Groundwater Model Assessment – Bowdens Silver Project

Comments on Chapter 5. Groundwater modelling in the report titled Bowdens Silver Part 5 Groundwater Assessment dated May 2020 by Jacobs Group (Australia) Pty Limited (pp 118–179).

Figure 4: Example of model report error: Incorrect line of best fit

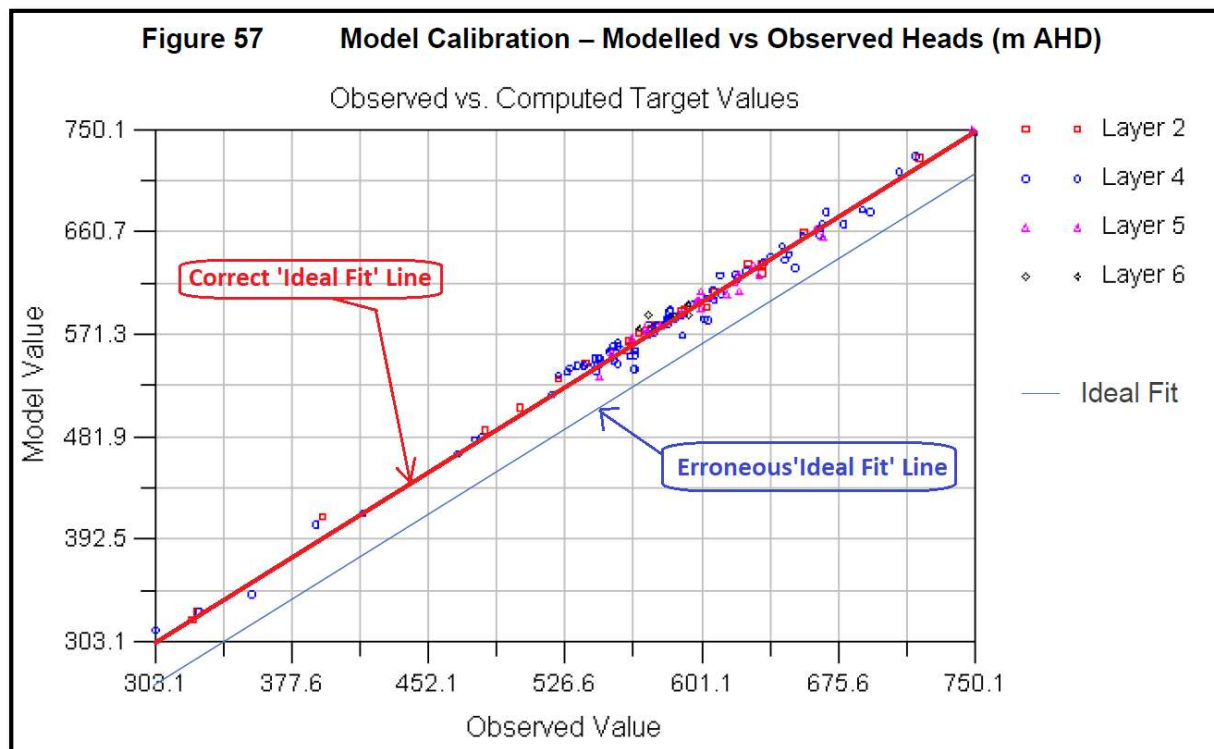
Issue / matter	Report reference	Department
		<ul style="list-style-type: none"> – Some figures need to be corrected. For example, the '<i>Ideal Fit</i>' line in Figure 57 is drawn incorrectly, suggesting that the model consistently overestimated head, whereas this is not the case (see Figure 4 below). – The scale (minimum, maximum and division of axes) in many figures is not user-friendly. For example, a more user-friendly scale will help the reader to understand the model performance more readily from the data presented in Figure 57. Also, the addition of overestimation and under estimation lines (e.g. ± 10 m and ± 20 m lines) will help the reader understand the level of fit between observed heads and model estimates. – There is inconstancy in the use of space between values and units throughout the report. For example, there values and units presented with and without space in the same line in the first paragraph on page (2 km... and 2.2km...). Values and units must be presented in consistent format, preferable with separating space but not before the percentage sign where it is used. – Numbers are presented with and without thousands separators (e.g. 1,000 m/d in page 165 and 1420 μS/cm in page 172). In addition, numbers are presented using space and comma as thousands separator (e.g. 2 746 in Table 37 on page 157 and 1,000 m/d in page 165). Consistency in number formatting is recommended, preferably using comma as thousands separator. – There are cross-referencing errors. For example, in the beginning of Section 5.3.2.2 (page 129) the reference to Figure 41 is incorrect. It should be changed to Figure 43. – There are grammatical errors and verb mismatches, e.g. '<i>Figure 54 and Figure 55 presents...</i>' at the bottom of page 143. – There are spelling errors, e.g. losses must be corrected to loses at the end of the first paragraph in Section 5.3.3.3 (p 157). – There is unhelpful/unspecific cross-referencing, e.g. '<i>Detail of the resultant hydraulic conductivity fields are presented further below</i>' on page 144, without citing the section, page, table, or figure. – There is inconsistency in the use of punctuation marks, e.g. comma/semi comma mix in the same bullet points set on page 164.
